Access Compliance Report Public Rights-of-Way (Curb Ramps)

Main Street: YORBA_LINDA_BLVD Cross Street: CARTHAGE_ST Location: NW

ADA ID: RPAT210917141550 Ramp Type: Type 1 - Perpendicular Diagonal Initial Pass/Fail: Pass Overall Compliance: No Severity Score: 0

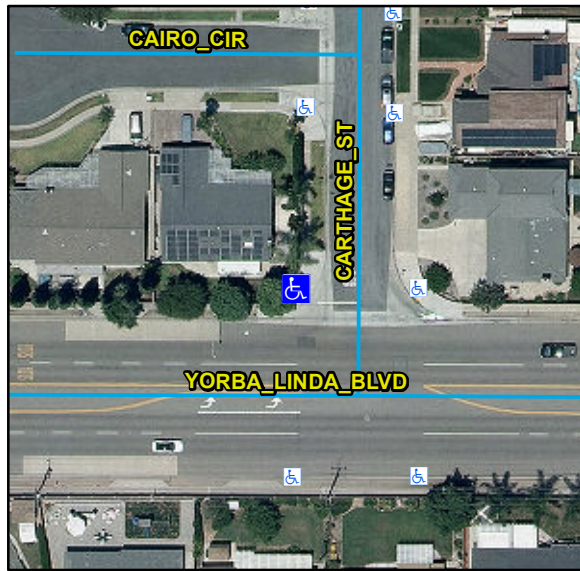
R304.2.2, R304.2.1, STD 1115

Remove & Replace Curb Ramp With Two New Directional Ramps or Equivalent.
